09/845,255
 05/01/2001
 Tomohisa Yamamoto
 108421-00013
 2846

Application No.	Applicant(s)
Office Action Summary		09/845,255	YAMAMOTO ET AL.
		Examiner	Art Unit
		Timothy L Rude	2871
Period for	The MAILING DATE of this communication app Reply	ears on the cover sheet with the c	
I HE M - Extens after S - If the p - If NO p - Failure - Any rep	PRTENED STATUTORY PERIOD FOR REPLY IAILING DATE OF THIS COMMUNICATION. ions of time may be available under the provisions of 37 CFR 1.13 IX (6) MONTHS from the mailing date of this communication. eriod for reply specified above is less than thirty (30) days, a reply eriod for reply is specified above, the maximum statutory period we to reply within the set or extended period for reply will, by statute, ply received by the Office later than three months after the mailing patent term adjustment. See 37 CFR 1.704(b).	i6(a). In no event, however, may a reply be tin within the statutory minimum of thirty (30) day ill apply and will expire SIX (6) MONTHS from cause the application to become ABANDONE	nely filed  s will be considered timely. the mailing date of this communication.

#### **DETAILED ACTION**

FIG. 2

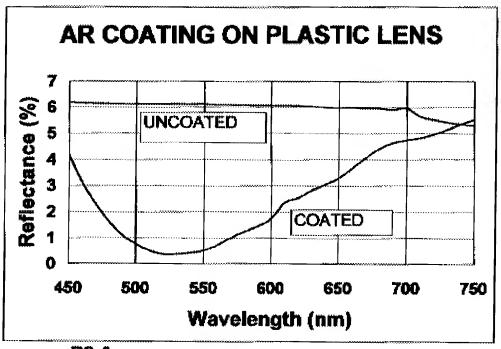
As to claims 1 and 16, Park discloses in Figure 1 an anti-static film for a display (materials embedded in hardcoat layer, col. 6, lines 19-23), comprising a hardcoat layer, 11, provided on the surface of a transparent substrate, 10, wherein said hard coat layer contains at least polymer (Applicant's resin) (col. 4, lines 6-11), Antimony Tin Oxide (Applicant's conductive material) (col. 4, lines 42-46), and silica (Applicant's low refractive index material) (col. 6, lines 10-23), surface electric resistance thereof is 1.7 X  $10^6 \Omega/\Box$  to 2.3 X  $10^6 \Omega/\Box$  (col. 7, lines 9-16) (less than Applicant's 1.0 X  $10^{11} \Omega/\Box$  or

less), and the 5-degree specular reflectance (col. 7, lines 31-38) is 4.0% or less (Figure 2).

Park does not explicitly disclose the exact range of surface electrical resistance and the exact range of Y value obtained by 5 degree specular reflectance. However, the ranges taught by Park, above, are within the respective claimed ranges. Therefore the narrower ranges of Park read on the claimed ranges for surface electrical resistance and 5 degree specular reflectance.
